CONTRACT CHANGE ORDER NO. _____
SHEET ___ OF ___

MARK	DATE	DESCRIPTIONS	BY	CH'D	CCO#
2	04/08/11	SUSPENSION CABLE MISCELLANEOUS DETAILS	GB	MN	185
1	01/28/11	MISCELLANEOUS CABLE SYSTEM DETAILS	GB	MN	37S1

SAN FRANCISCO OAKLAND BAY BRIDGE
EAST SPAN SEISMIC SAFETY PROJECT
SELF-ANCHORED SUSPENSION BRIDGE
(SUPERSTRUCTURE & TOWER)
EAST CABLE ANCHORAGE "E" LINE LAYOUT NO. 2

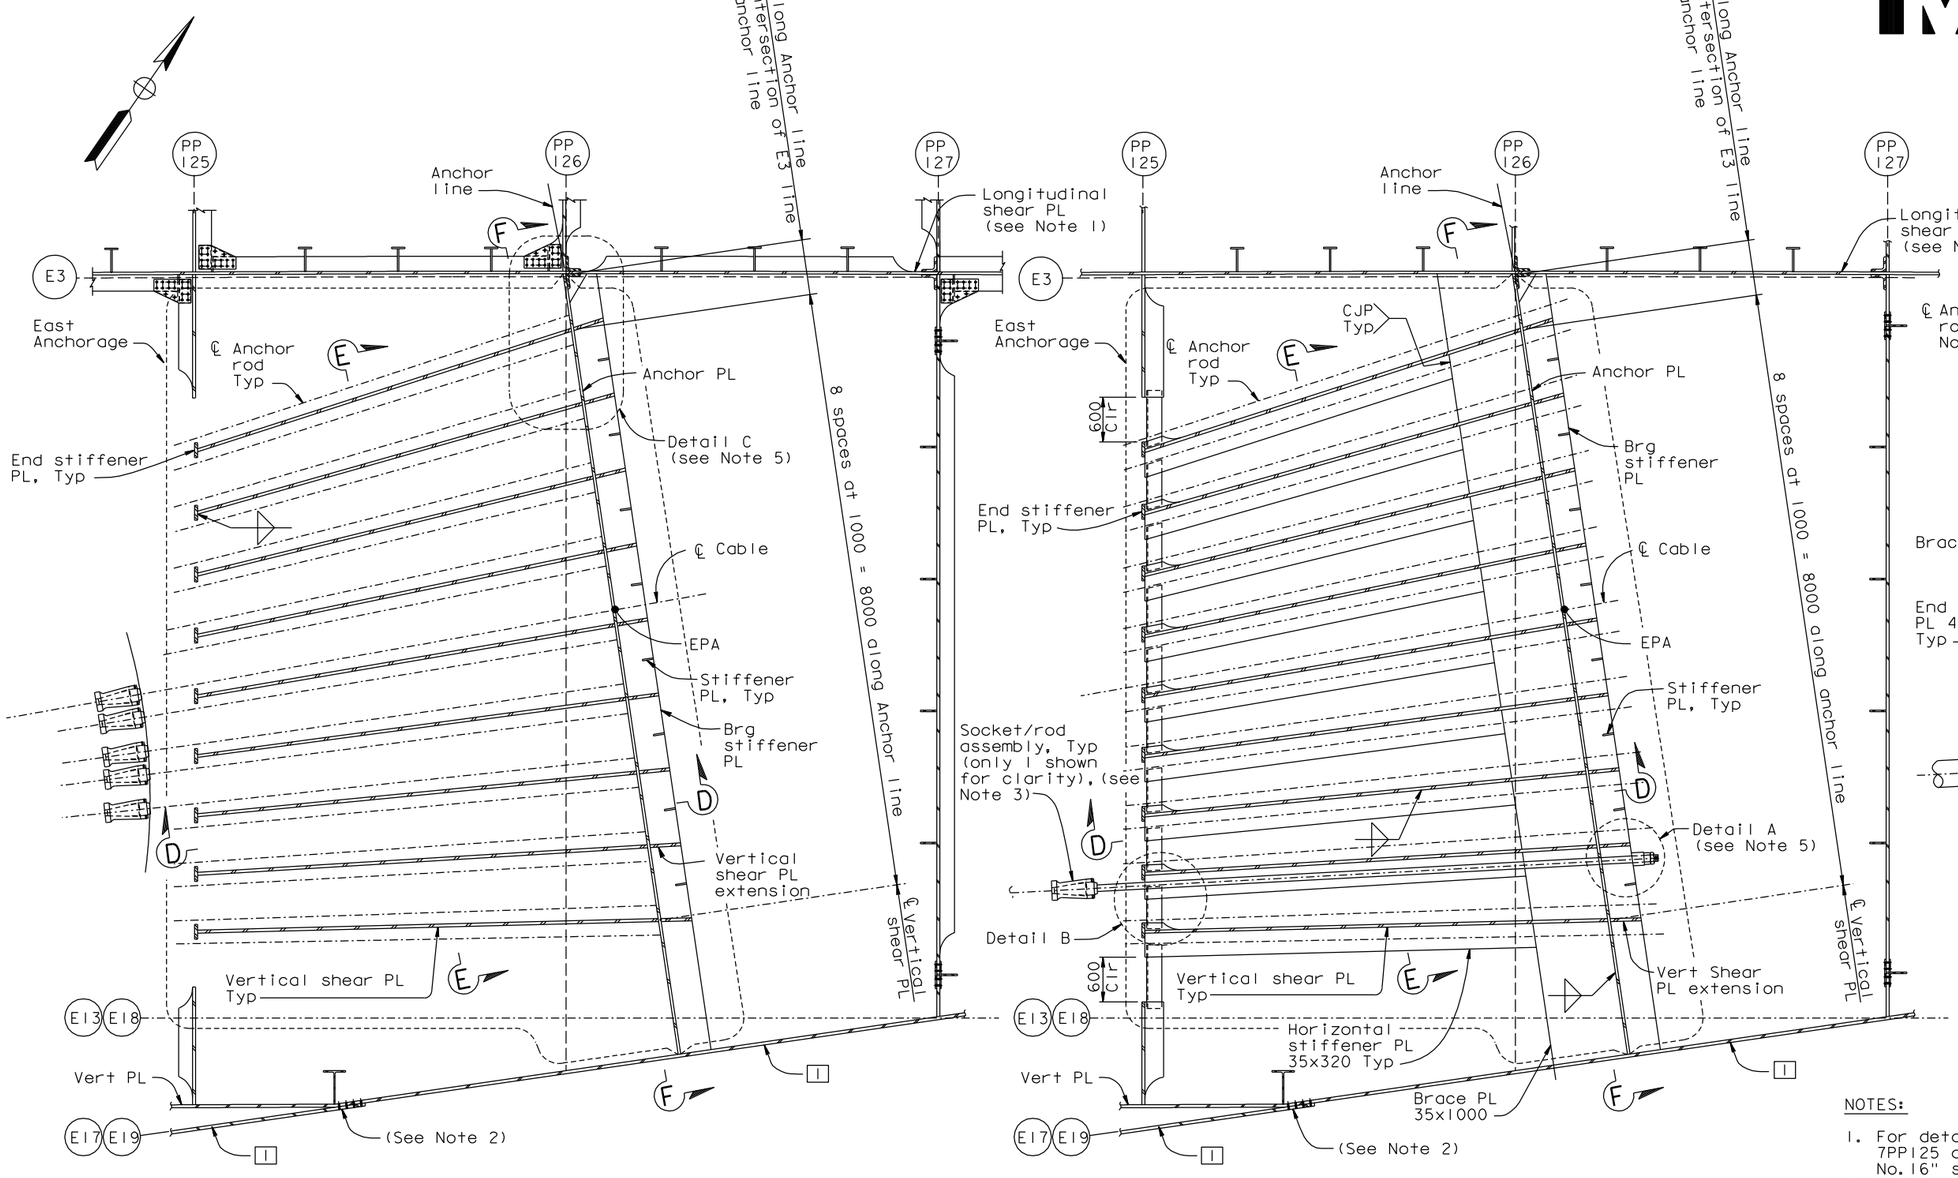
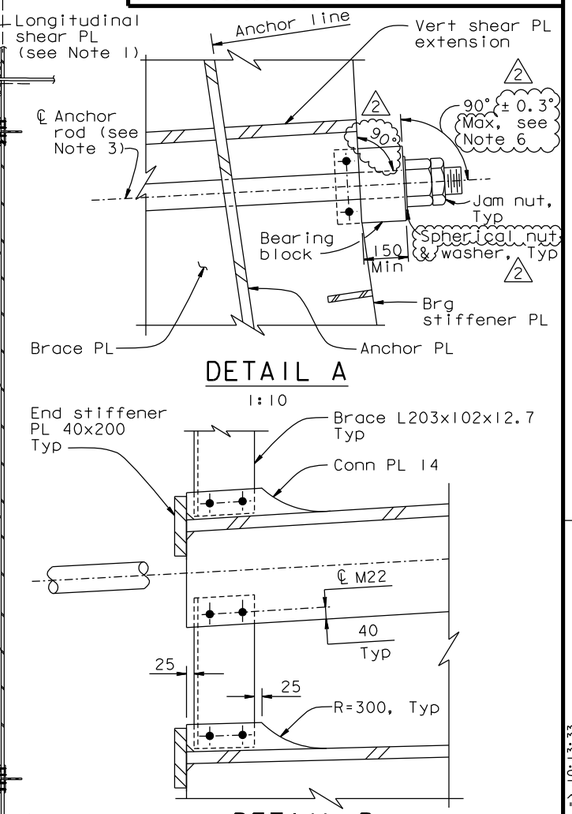
6. The bearing blocks shall be aligned with the bearing stiffener plates. The angle between the bearing block and the anchor rod may vary (up to 90° ± 0.3° Max) due to the averaging of the bearing stiffeners orientation across each row of anchors.

EAST CABLE ANCHORAGE "E" LINE LAYOUT NO. 3

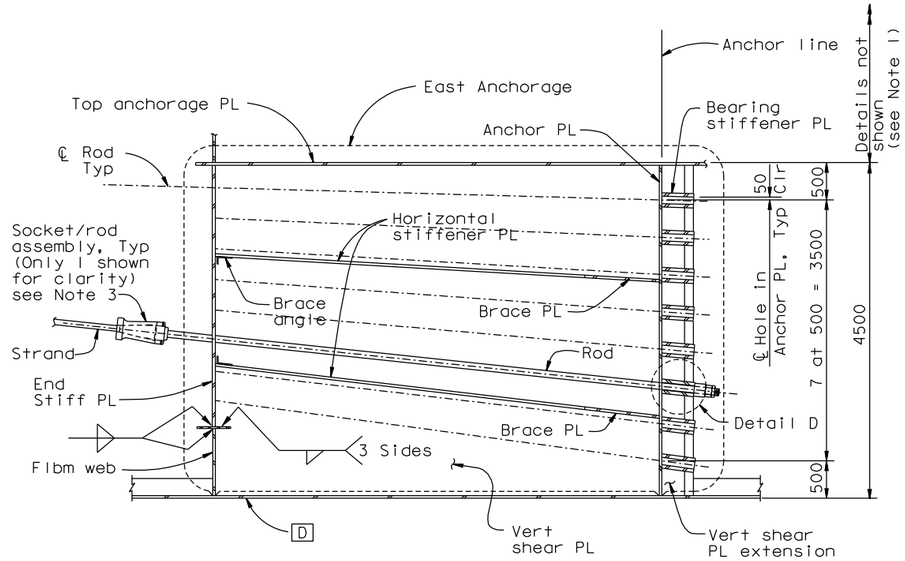
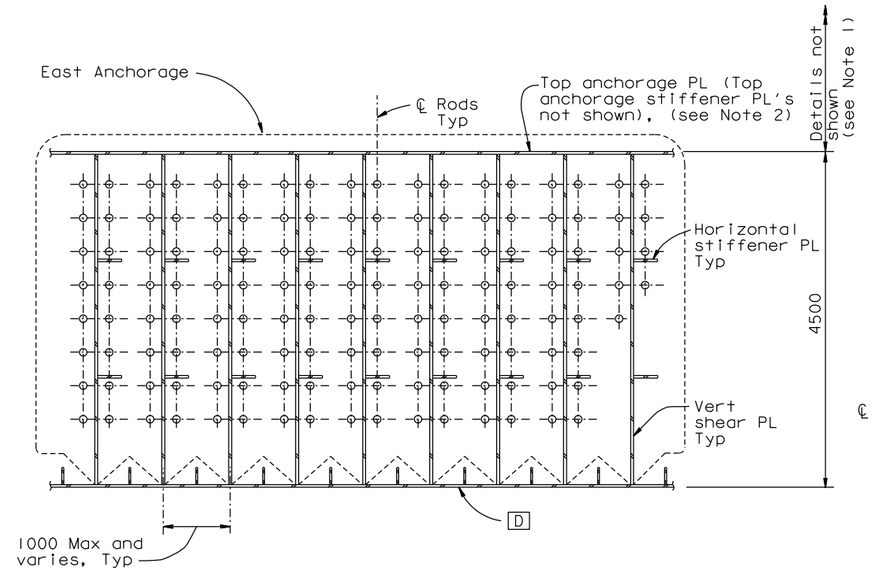
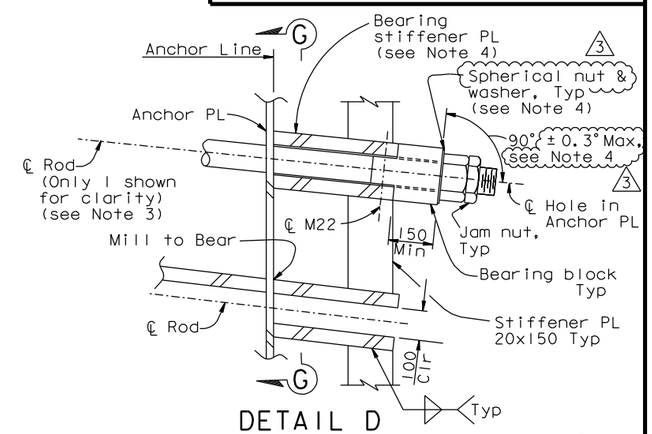
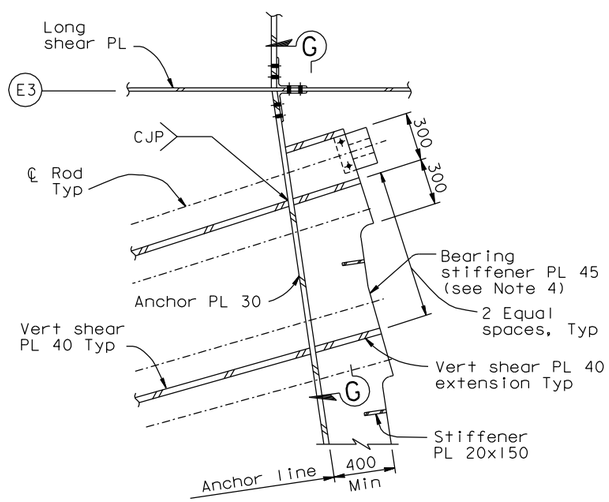
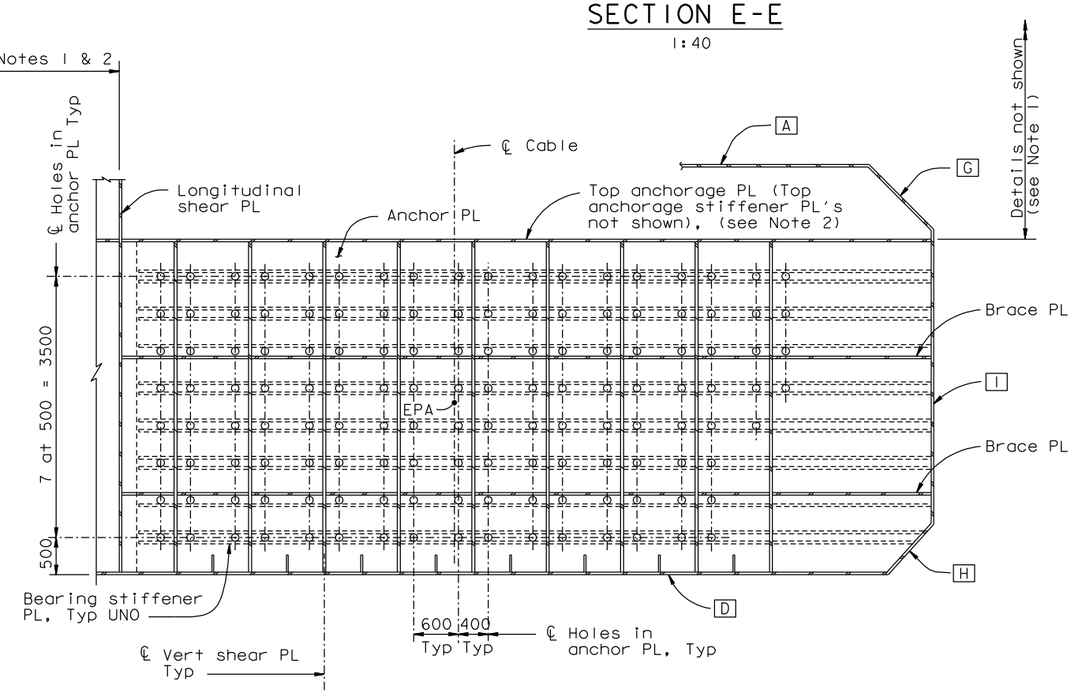
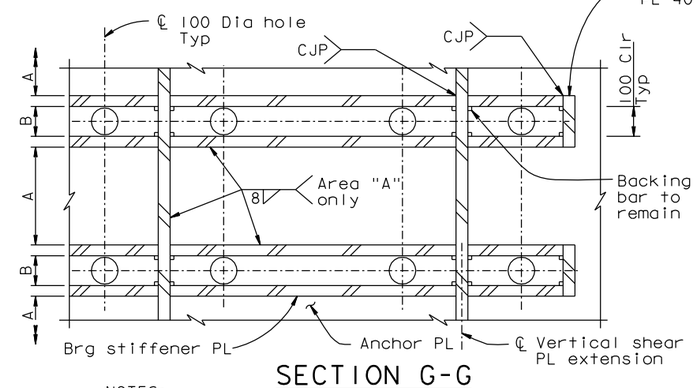
MARK	DATE	DESCRIPTIONS	BY	CH'D	CCO#
3	03/25/11	SUSPENSION CABLE MISCELLANEOUS DETAILS	DT	GB	185
2	01/28/11	MISCELLANEOUS CABLE SYSTEM DETAILS	DT	GB	37S1
1	08/28/09	BEARING BLOCKS	DT	GB	78

SAN FRANCISCO OAKLAND BAY BRIDGE
EAST SPAN SEISMIC SAFETY PROJECT
SELF-ANCHORED SUSPENSION BRIDGE
(SUPERSTRUCTURE & TOWER)
EAST CABLE ANCHORAGE "W" LINE LAYOUT NO.2

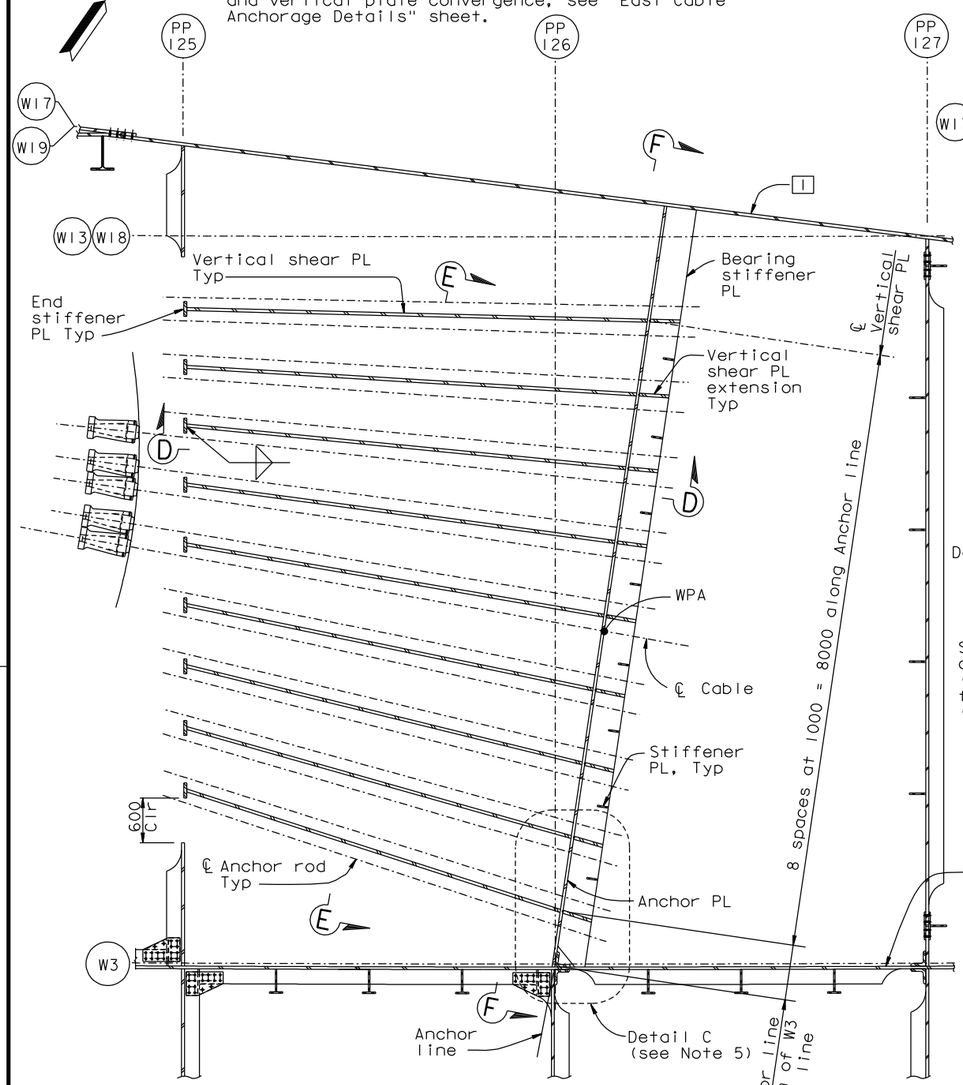
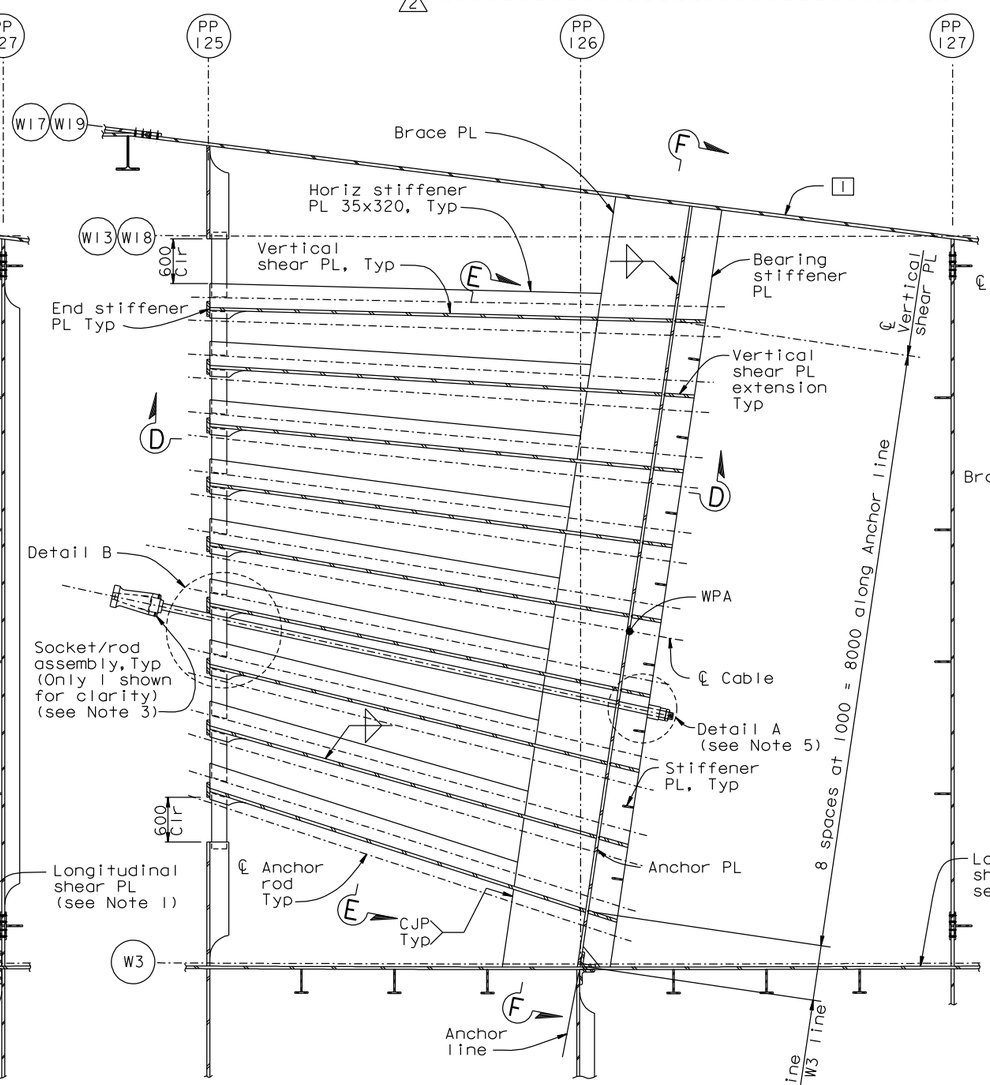
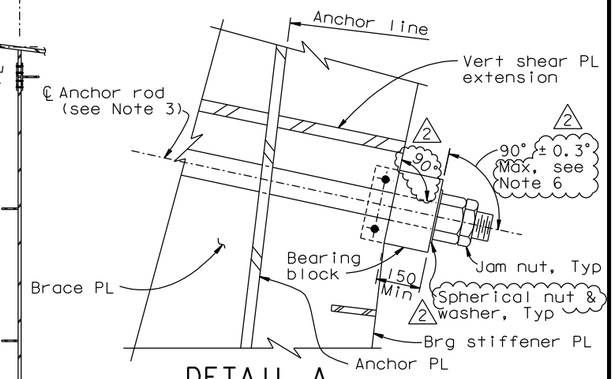
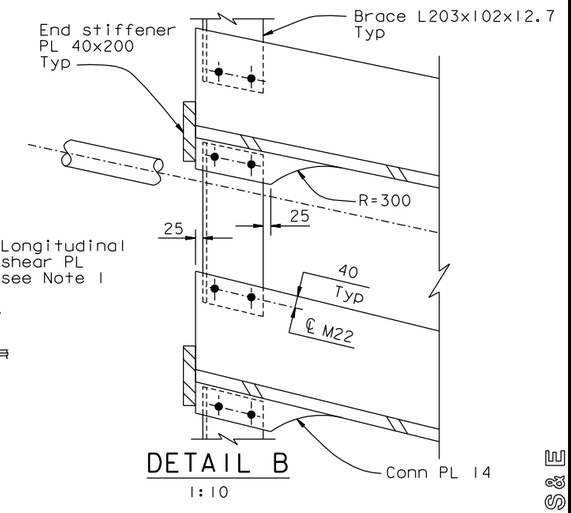
MARK	DATE	DESCRIPTIONS	BY	CH'D	CCO#
2	04/08/11	SUSPENSION CABLE MISCELLANEOUS DETAILS	GB	MN	185
1	01/28/11	MISCELLANEOUS CABLE SYSTEM DETAILS	GB	MN	37S1

EAST CABLE ANCHORAGE "W" LINE LAYOUT NO. 3

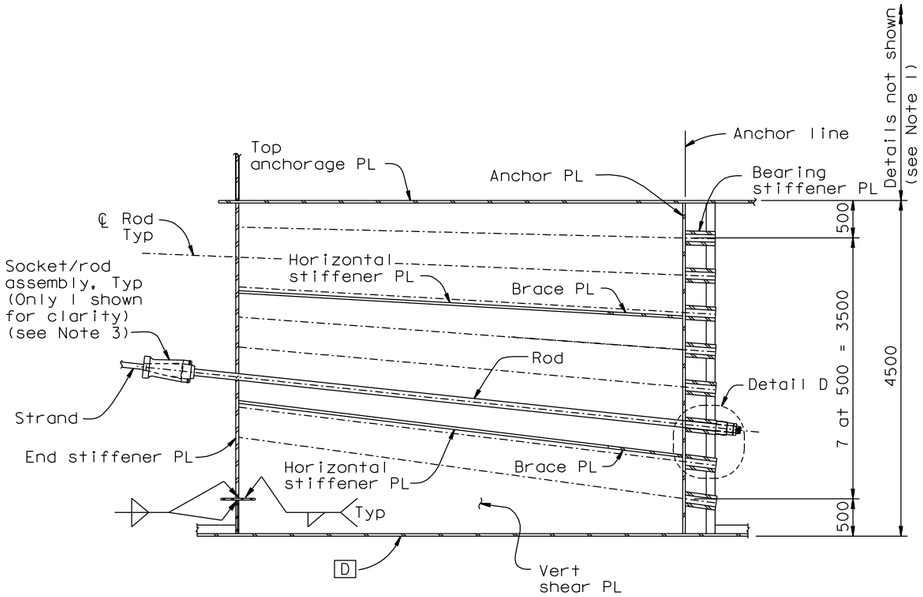
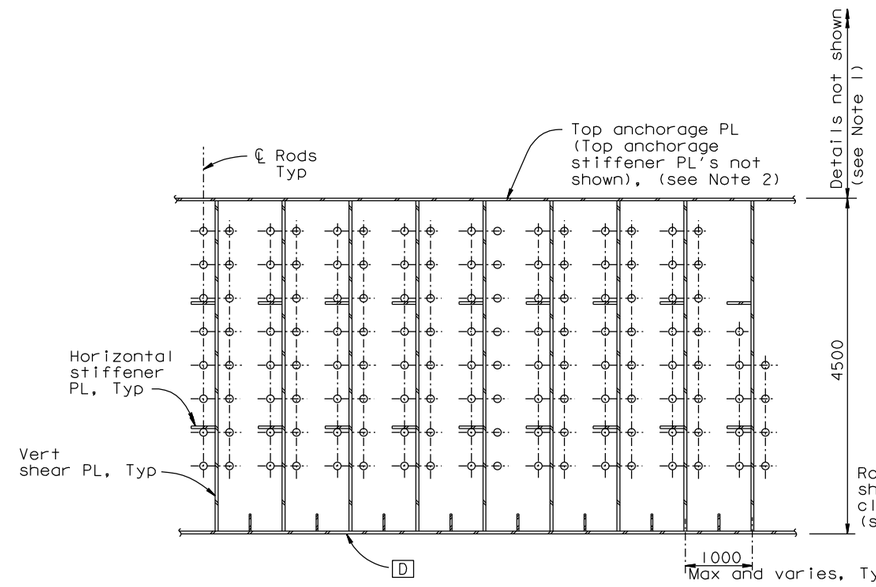
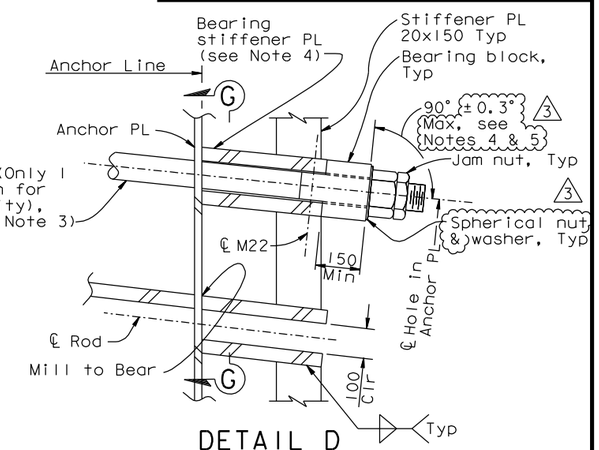
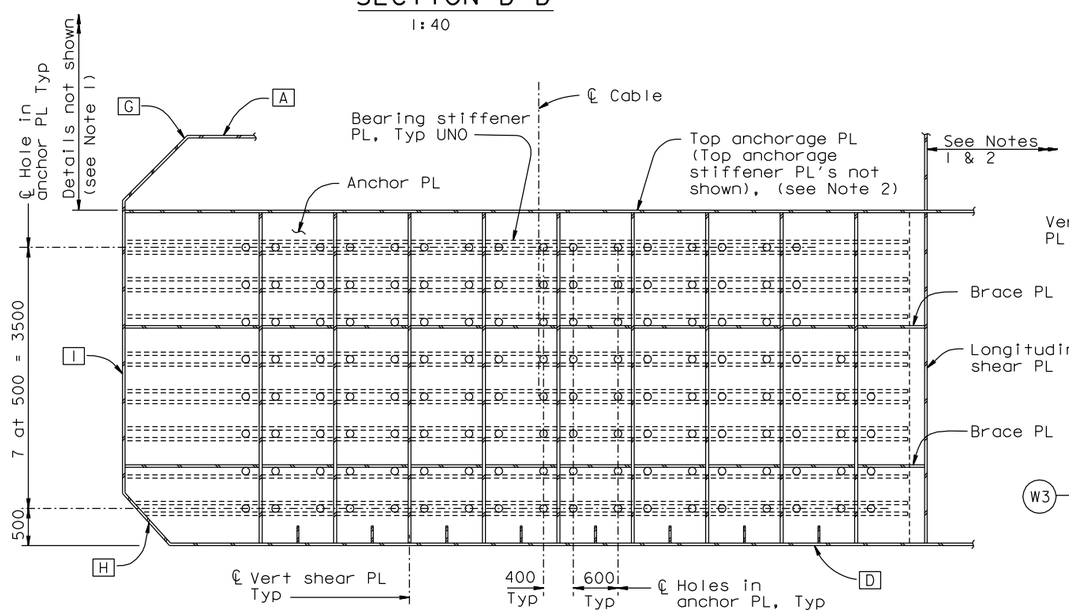
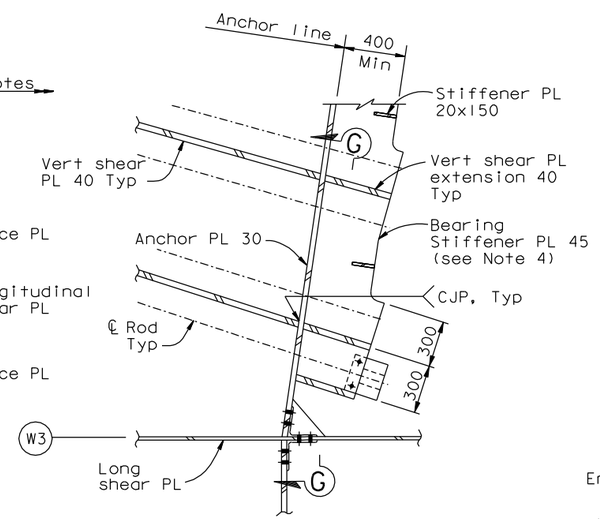
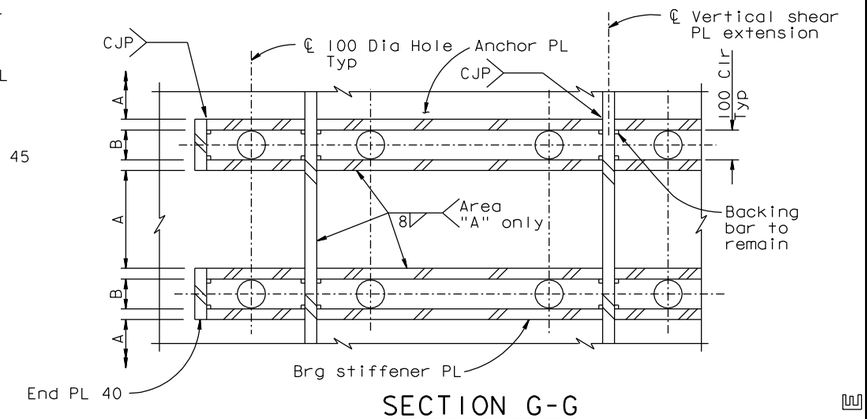
MARK	DATE	DESCRIPTIONS	BY	CH'D	CCO#
3	03/25/11	SUSPENSION CABLE MISCELLANEOUS DETAILS	DT	GB	185
2	01/28/11	MISCELLANEOUS CABLE SYSTEM DETAILS	DT	GB	37S1
1	08/28/09	BEARING BLOCKS	DT	GB	78
